**Responsible Authority Report
- 78/2014/A**

Form 2 - Responsible Authority Report

Property Location:	Lot 1010 (9) Hawksburn Road Rivervale
Application Details:	85 Dwellings (75 Multiple Dwellings and 10 Grouped Dwellings)
DAP Name:	Metro Central JDAP
Applicant:	Rowe Group
Owner:	Statesman Homes Pty. Ltd.
LG Reference:	78/2014/DAP/A
Responsible Authority:	City of Belmont
Authorising Officer:	Neville Deague – Director Community and Statutory Services
Department of Planning File No:	DP/14/00141
Report Date:	Submitted to DAP on 30 September 2014
Application Receipt Date:	11 August 2014
Application Process Days:	35 Days
Attachment(s):	<ol style="list-style-type: none"> Joint Development Assessment Panels Approval (7 May 2014) Amended Development Plans and Supporting Information from Applicant (11 August 2014)

Community Room / Gymnasium (Ground Floor – Plan A201)

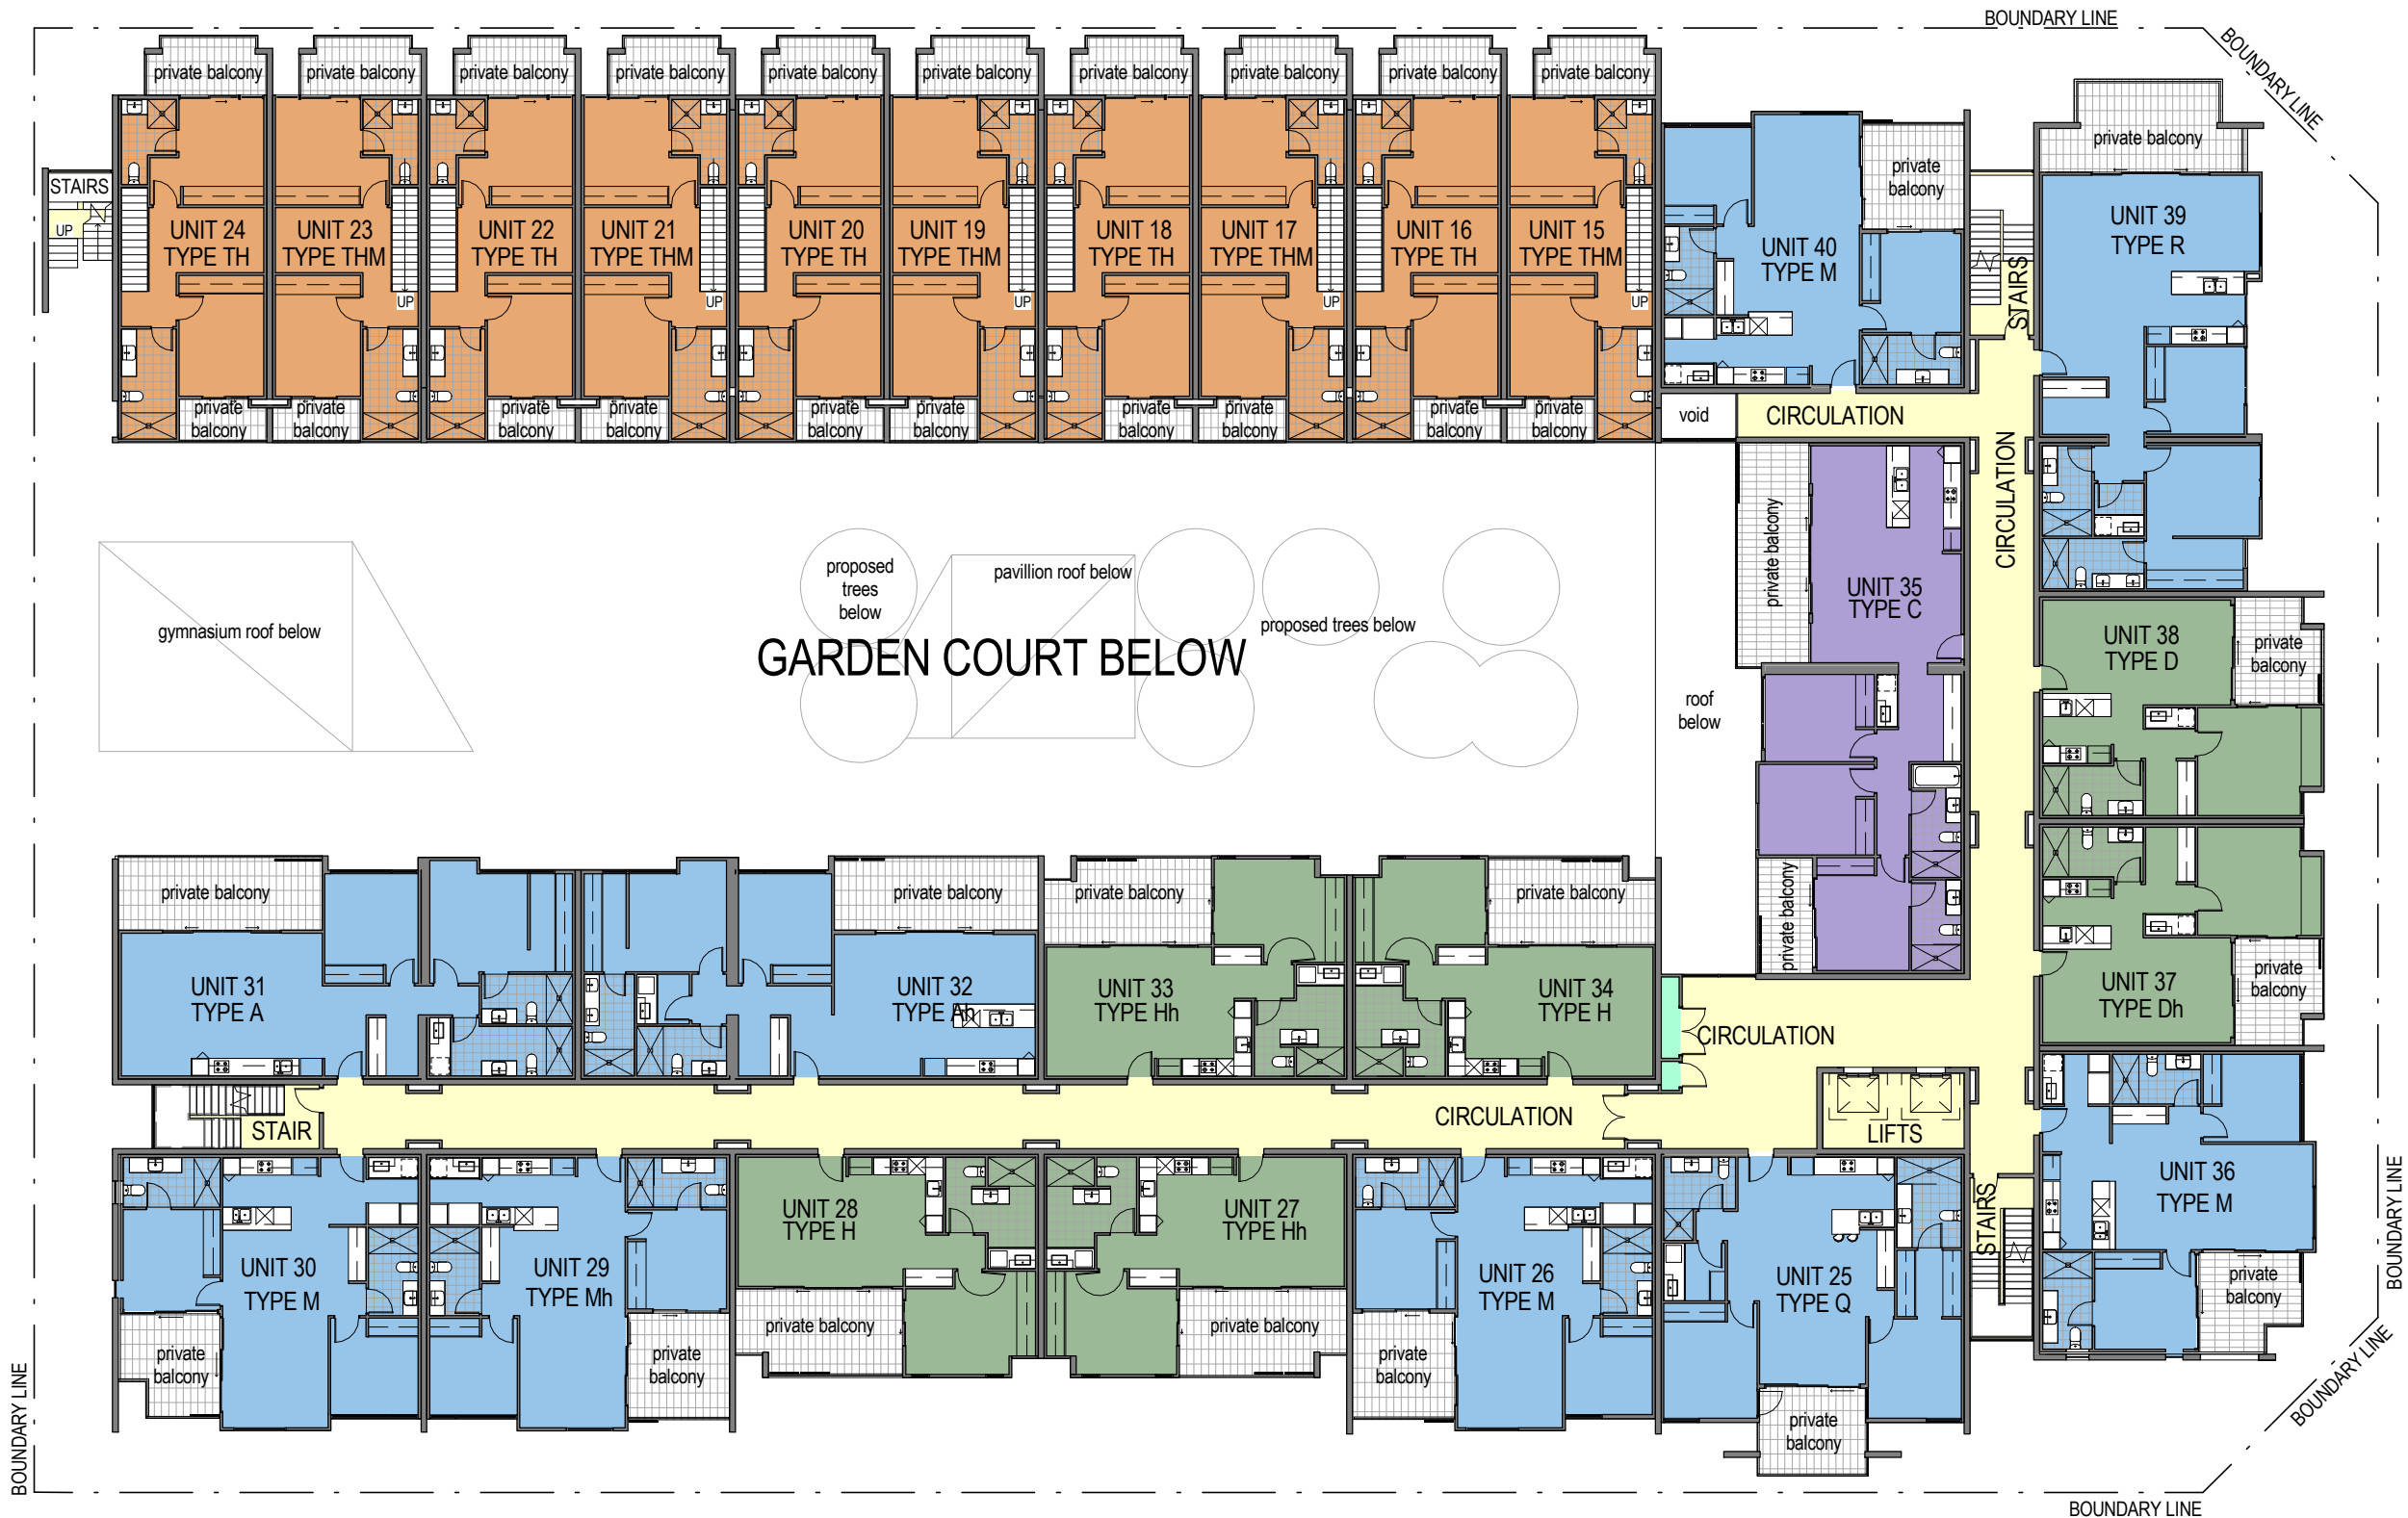
The amended plans propose a revised layout to the communal facilities on the ground floor of the development. The gymnasium has been relocated adjacent to the pool area to provide for a larger and more open community room in its previous location. The community room now includes kitchen, scullery, disabled toilet and lounge facilities which were not previously proposed and increases the overall amenity provided to the future occupants of the development.

The proposed modifications are internal to the development do not result in additional plot ratio area being created. Further, it is considered the amendments result in a positive outcome for the development, with a higher level of communal facilities being provided for the future residents.
